9 May 2011

ADDENDUM NO. 2
Orsini Orthodontics

Orsini Orthodontics
 Revised partial plan
 1/4" = 1'-0" 9 May 11

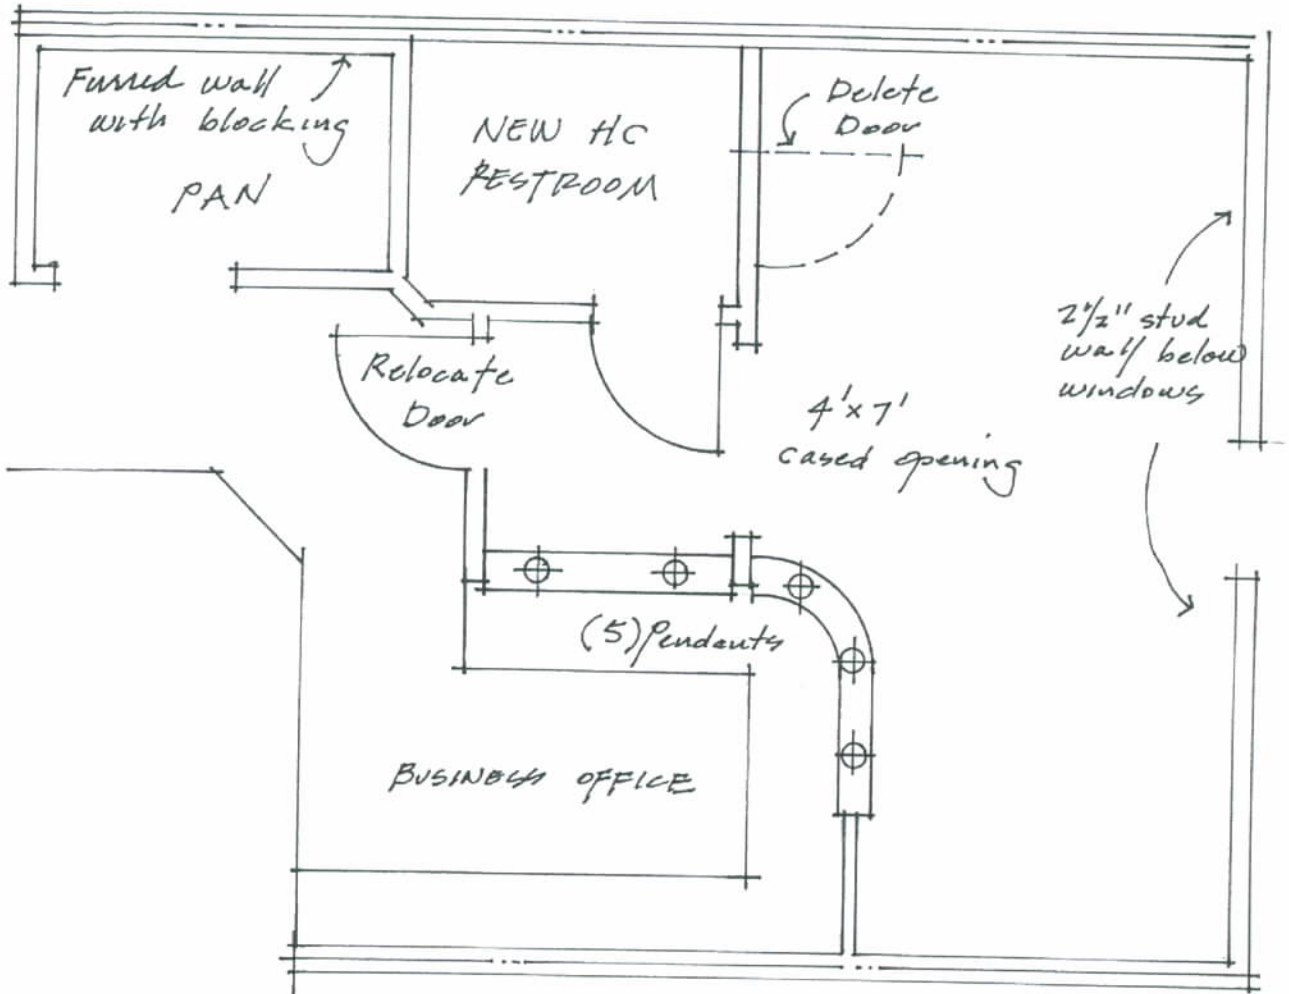
9. Crown is 5-1/2", one piece, profile will be selected from suppliers standard profiles.
10. "PAN" Gendex 9200 DDE Blocking Detail is WD7 on SA.3. The furring (2-1/2" 20 gauge metal studs), conduit and blocking can be installed on the inside of the existing fire wall.
11. See attached 'Revised Partial Plan' revising the front New HC Restroom door and checkout counter. Sketch also indicates the furred wall at PAN, new stub wall below storefront windows and the (5) pendant lights added per Addendum No. 1.
